Procurement of Plant for Design, Supply, Installation and Commissioning of Gas insulated 220kV Lapsipedi Substation, 132kV Changunarayan Substation and upgradation of Teku Substation and Suichatar Substation.				
ICB: PMD/PTDEEP/LCSCP-073/74RE-01				
CLARIFICATION 1 ISSUED BY NEPAL ELECTRICITY AUTHORITY				
SI N	Reference Section & Clause	Description	Bidder's Query/ Changes suggested	Client Response
General & Commercial				
1	SECTION 1- ITB CLAUSE NO 21	Bid Security	we presume that the BG against Bid security issued by an Indian bank is accepted to NEA and it is not required to have counter guaranteed by a commercial bank in Nepal? Please confirm.	Confirm
3	Vol-II	MV & EHV Cable Specification & Control and Power Cable	GTP and Technical Specification is not available for 72kV, 145kV and MV Cables and LT (power and control) Cables. Please provide the same.	Please Refer GTR, Chapter 22 - EHV XLPE and GTR, Chapter 9 - Power and Control Cable

CLARIFICATION 1 ISSUED BY NEPAL ELECTRICITY AUTHORITY				
SI N	Reference Section & Clause	Description	Bidder's Query/ Changes suggested	Client Response
		However, IF the Bidder/Manufacturer has not conducted the complete type tests including DSC i

Result of Earth Resistivity Testing at Changunarayan

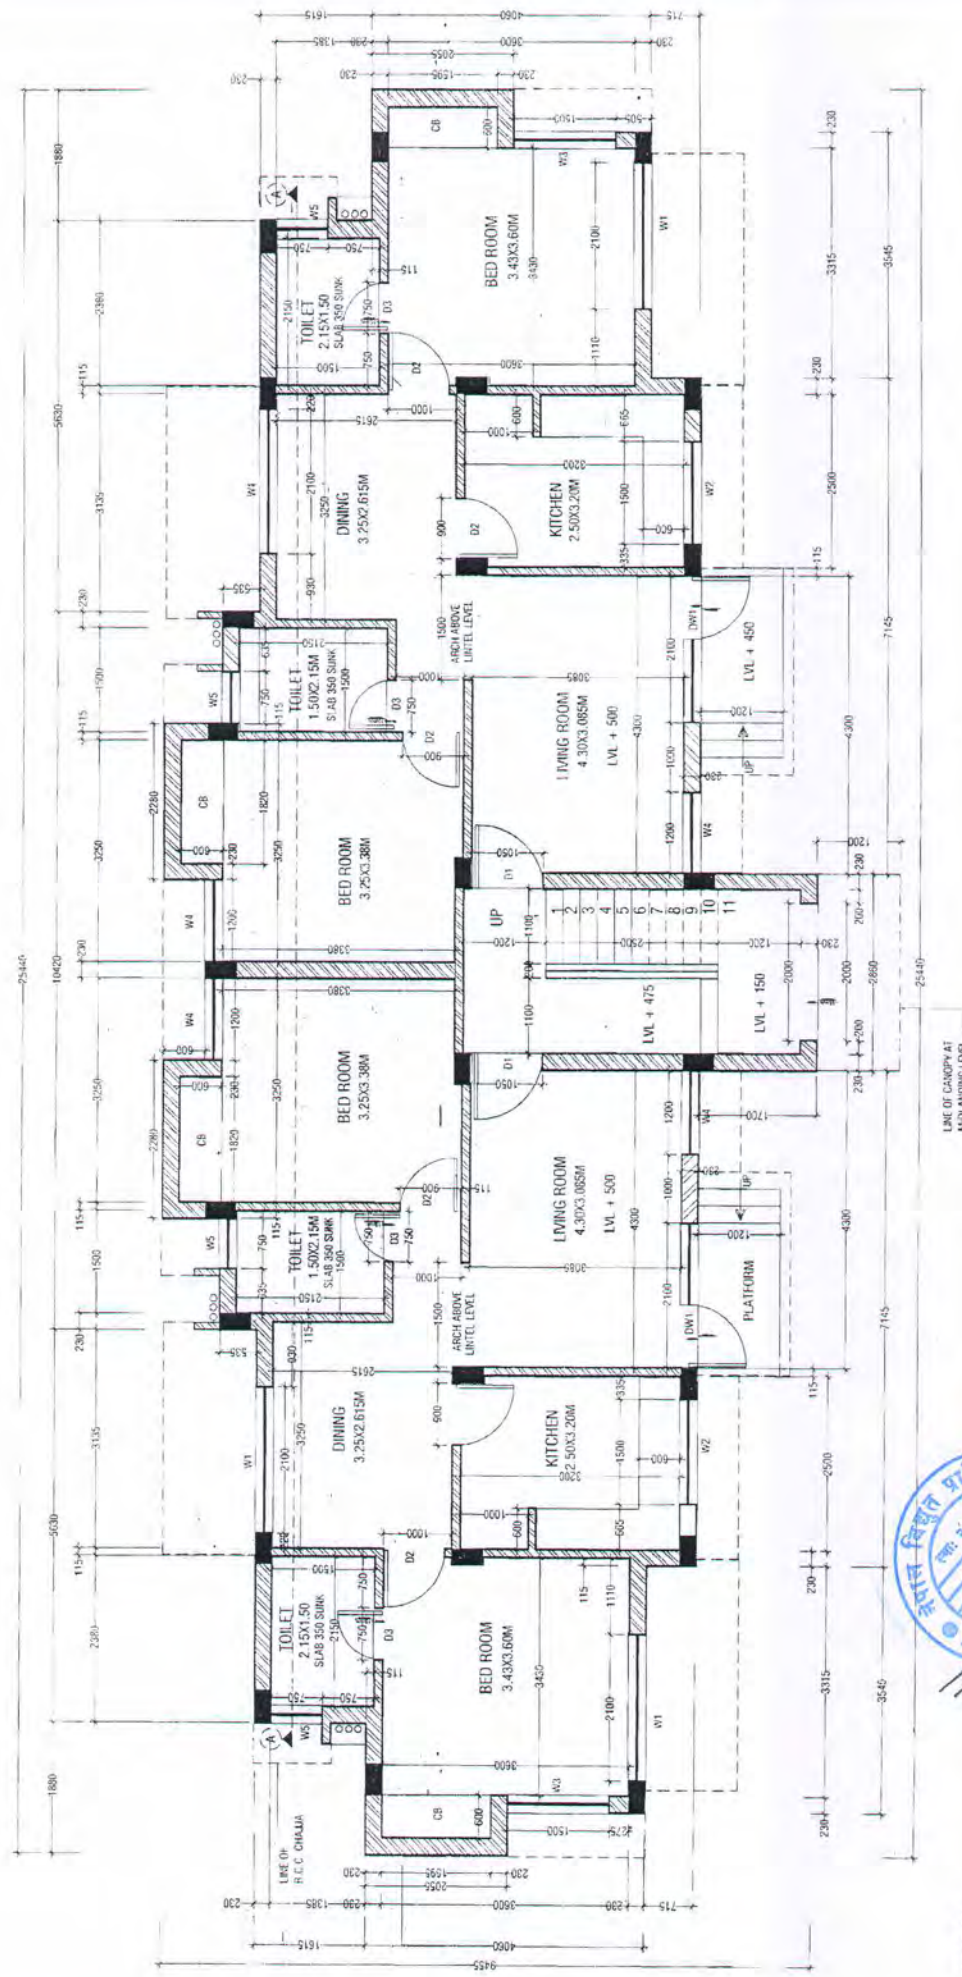
11	Vol-II, Project Specific Requirement (Chapter 1)	ERT Report	Please provide ERT report for all sites.	The measured value for Lapsephedi and changunarayan are attached. The successful bidder is required to retest to confirm the value.
12	Vol-II, Project Specific Requirement (Chapter 1)	Contouring	Please provide the countour plot for all sites.	Please visit the site for details. However, the successful bidder is required to do the detail survey.
13	Vol-II, Project Specific Requirement (Chapter 1)	Dismantling of 66kV GIS at Teku	The Dismantled GIS modules shall be stored in NEA stores as directed by the Employer. Please clarify the store loction and distance?	Store location within Kathmandu Valley

TITLE GROUND FLOOR PLAN (DOUBLE STOREY)  
TYPE - B2

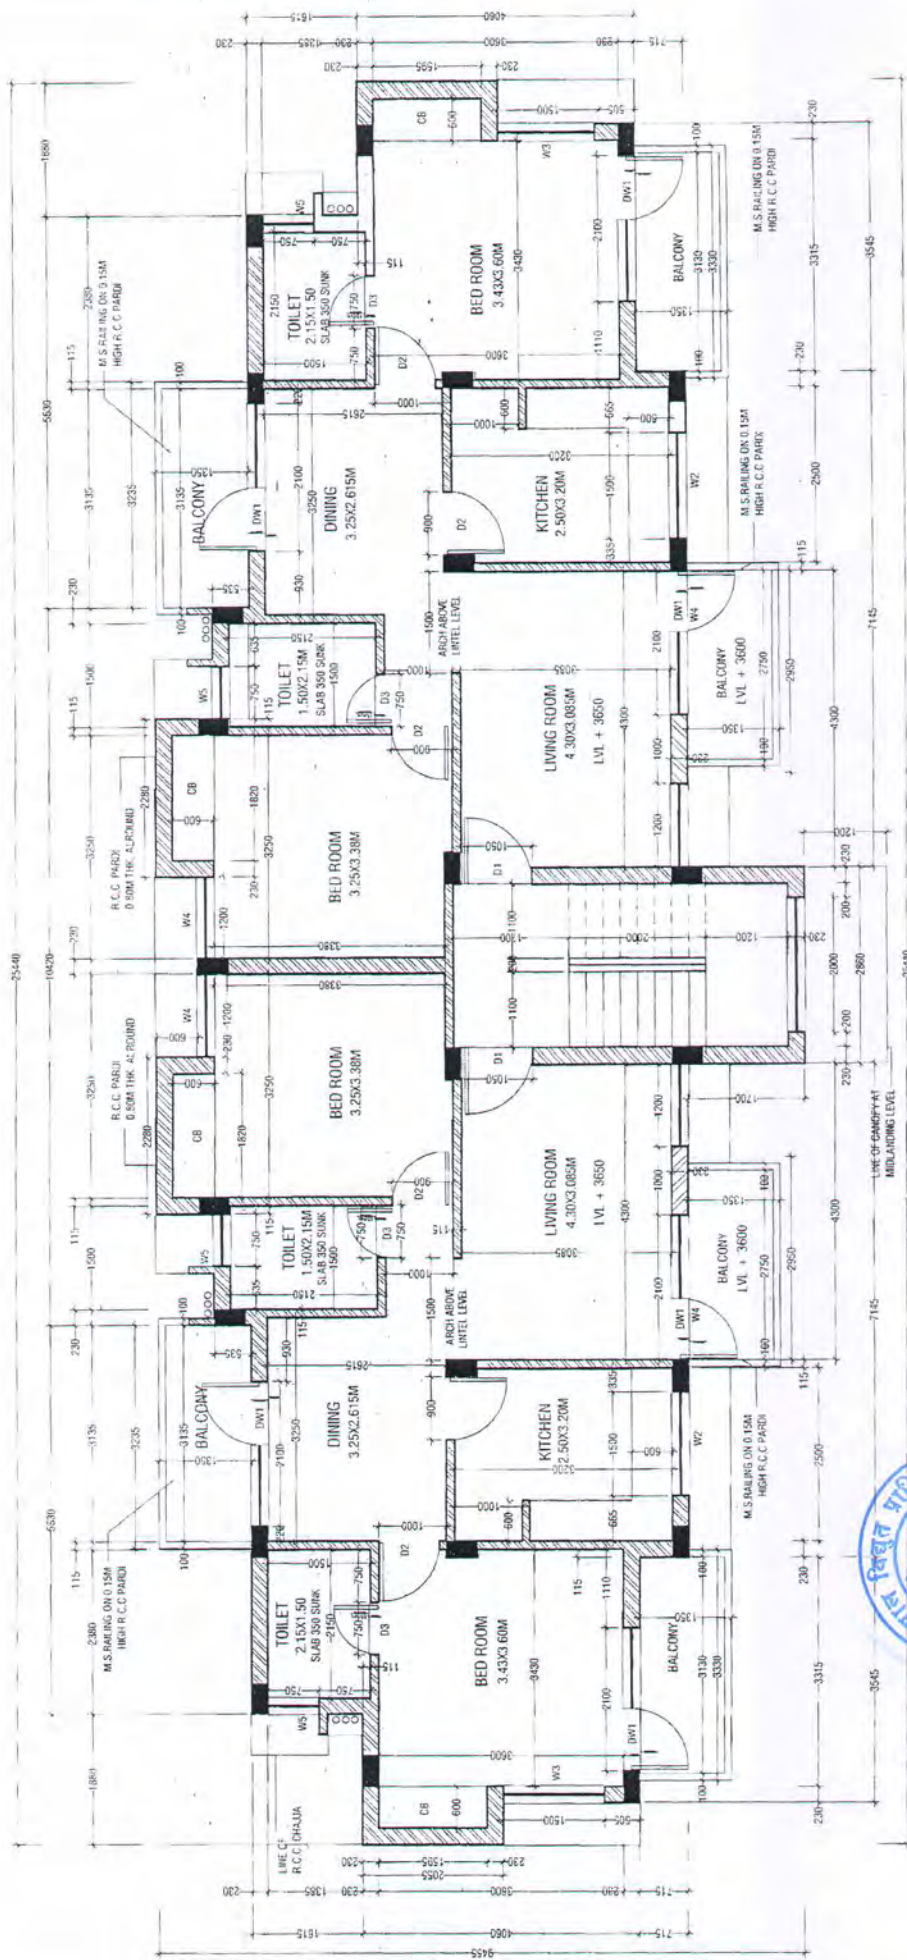
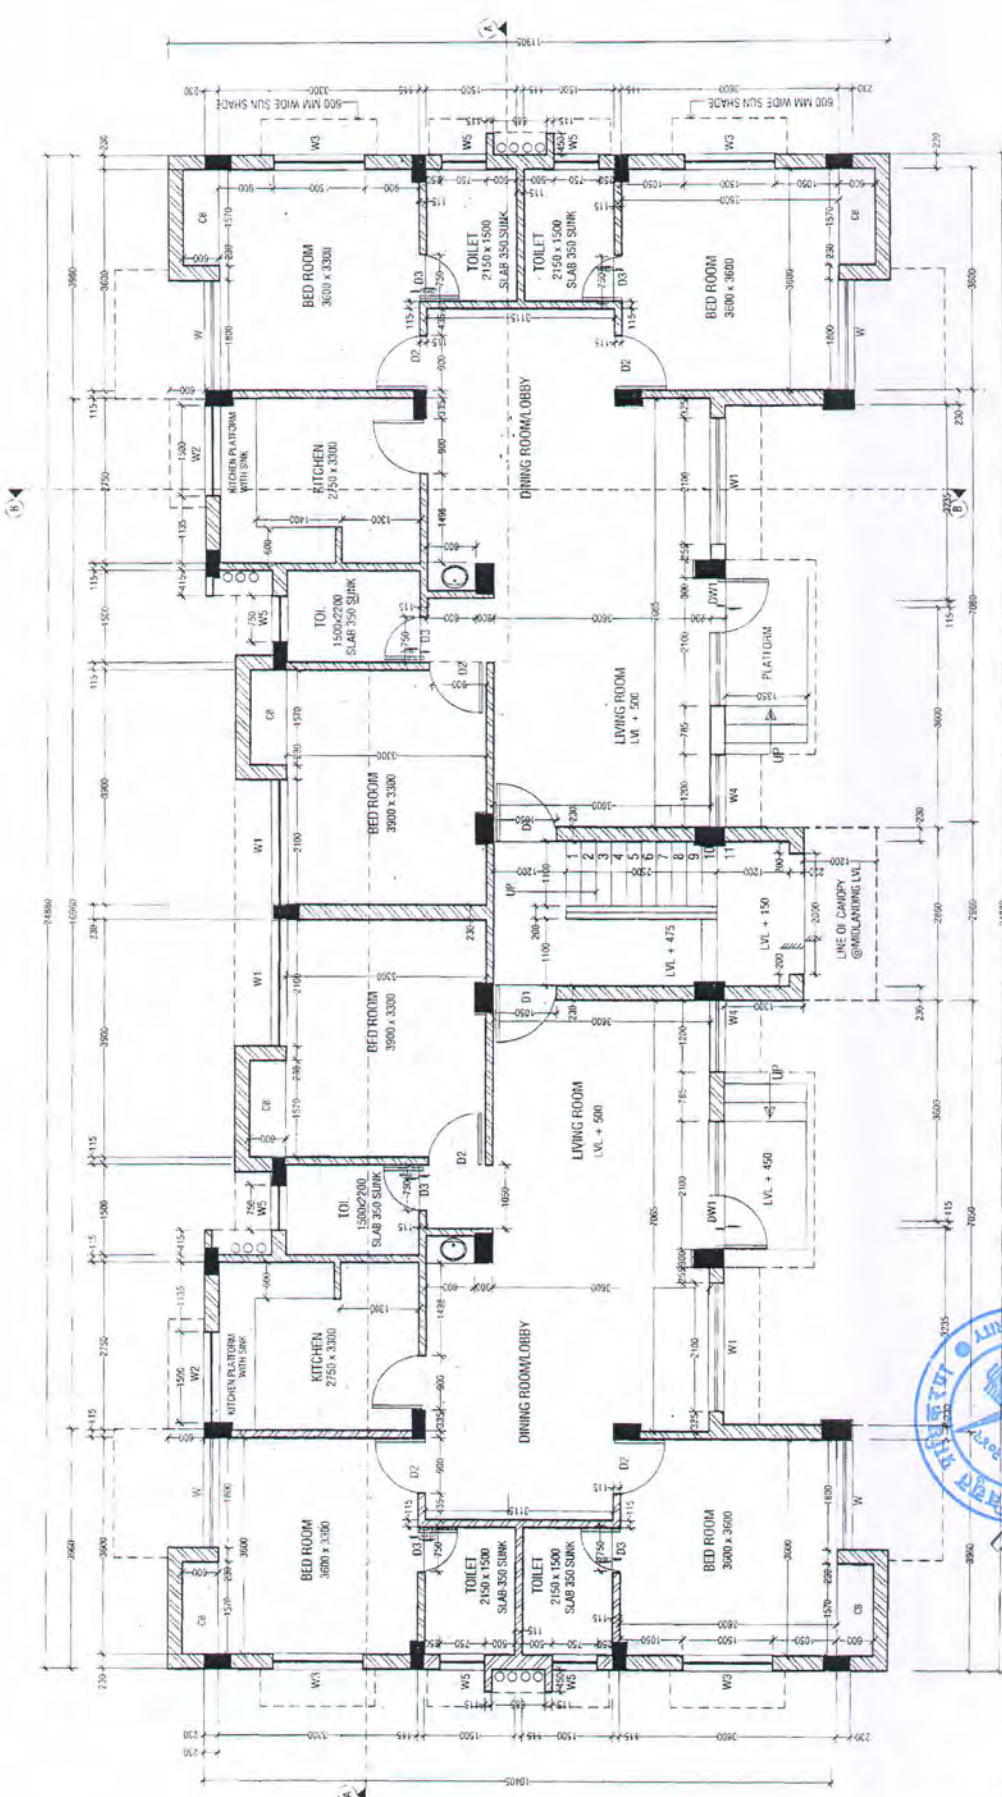
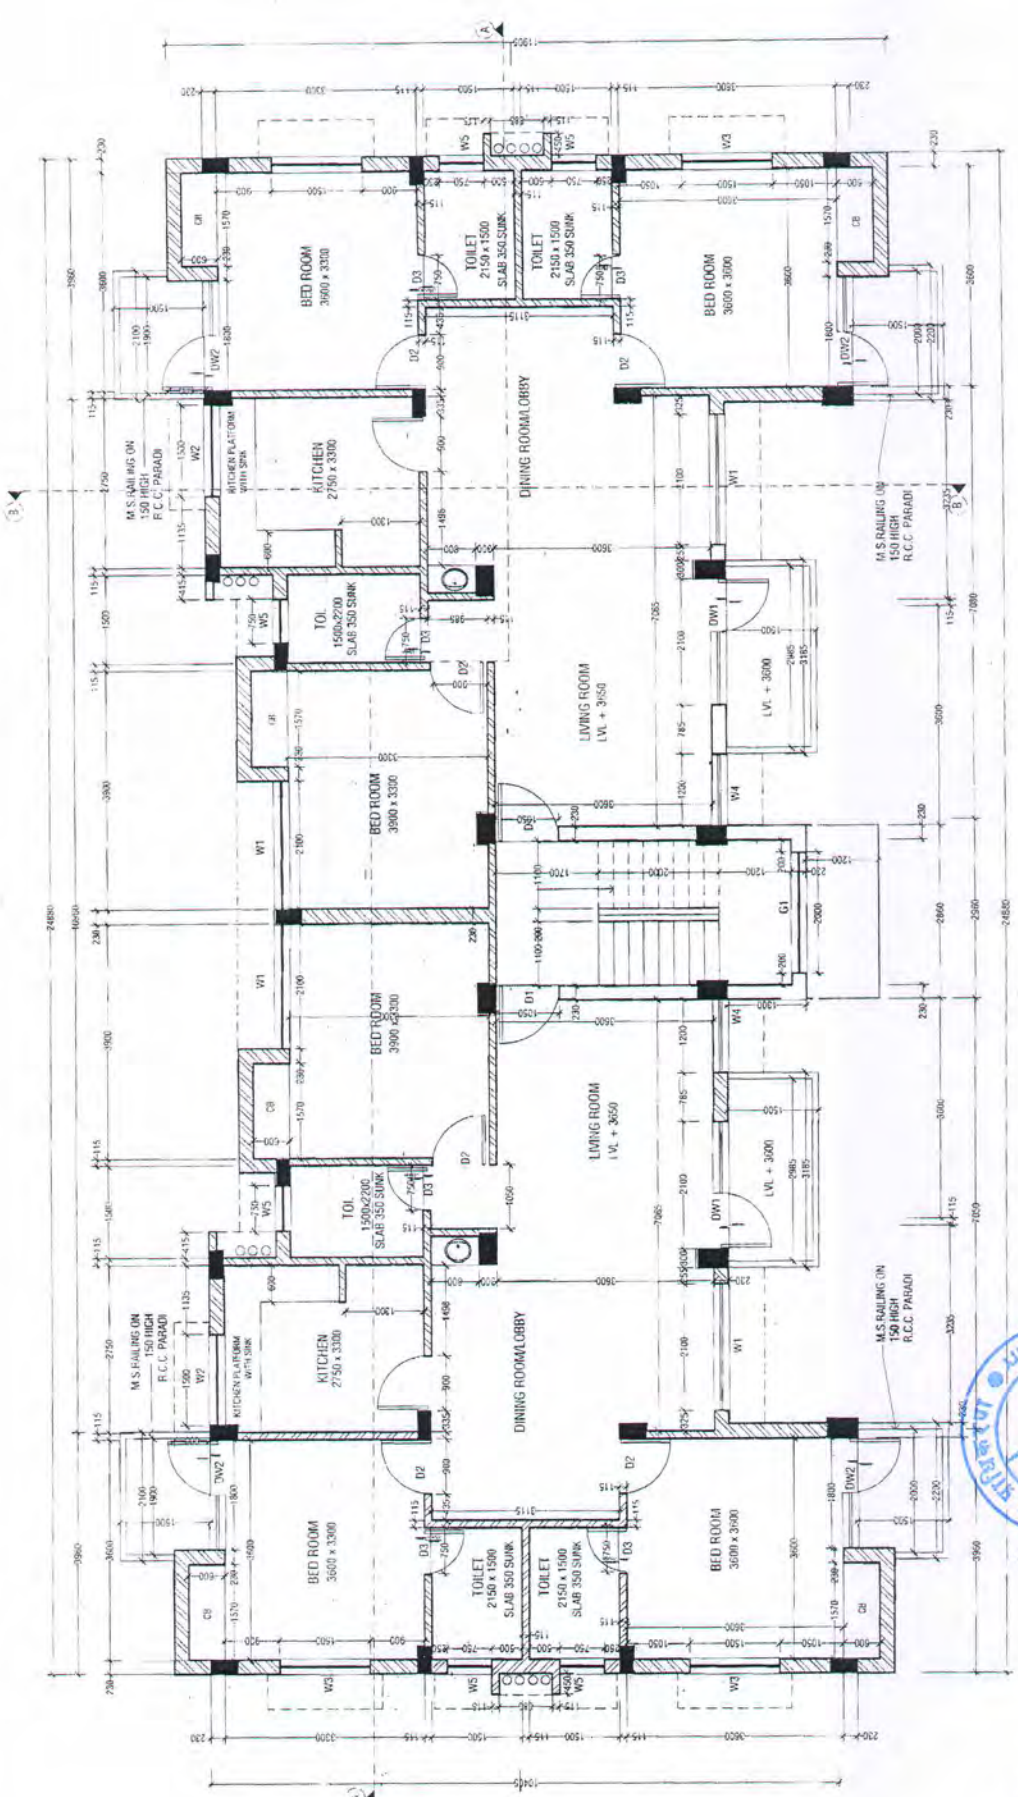
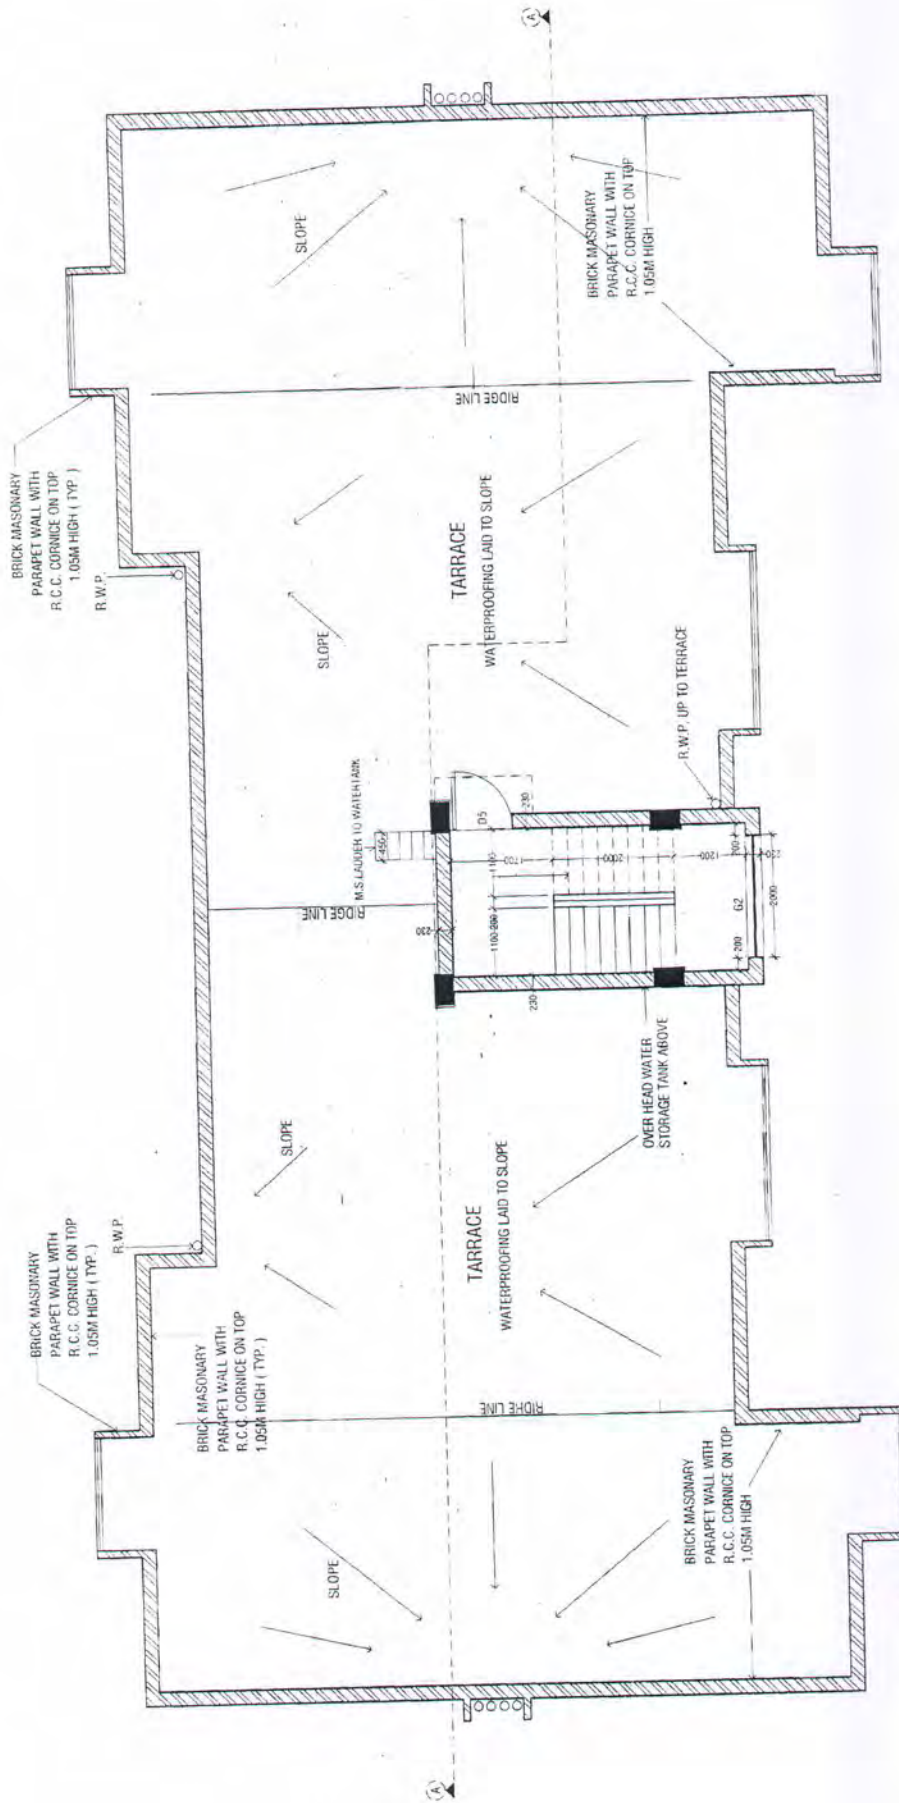
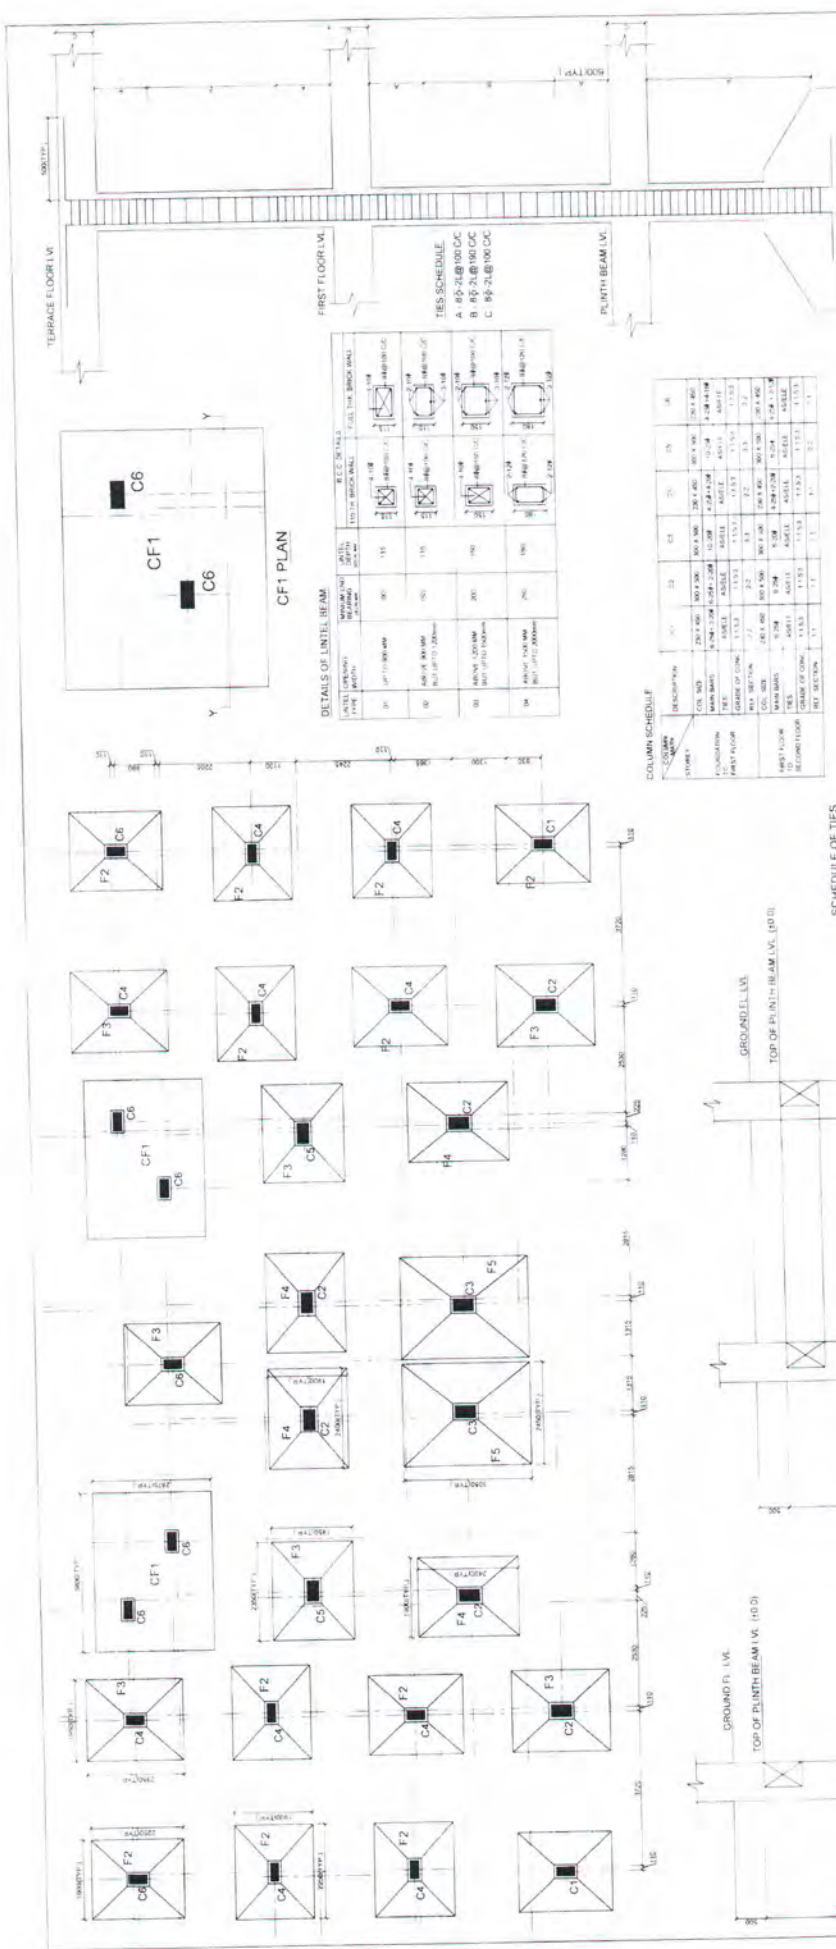
166	Volume II, CH-1 (Project Specification Requirement)	Clause no- 4.1.28 ( C)	As per referred clause , the Quarters buildings (B,C,D type) are in bidders scope. Please provide the following drawings to estimate the finishes quantity of the buildings.  1. Building Plan with room dimension. 2. Elevation of drawing. 3. Section details.	Please find the attached drawings.
167	Volume II, CH-1 (Project Specification Requirement)	Cl.no : 6.1 e	As per referred clause, seismic requirement for proposed substation is 0.5g which is very Severe and much higher than the maximum critical value in IS:1893. We have considered that, bidders shall do civil & Structural design. Please confirm.	Confirm
168	Volume II, CH-1 (Project Specification Requirement)	Clause no- 4.1.28 ( C) & 4.3.3	We presume that the pile foundation, Rubble soling or any additional foundation protection works is not envisaged for the proposed Lapsephedi & Teku Substation. If required the same shall be paid in additional item with mutually agreed rate. Please confirm.	If pile foundation is required at Lapsephedi, Suichatar or Teku Substation, the rate of Chanunaryan BPS will be considered. The existing GIS cum control building at Teku is on normal foundation.
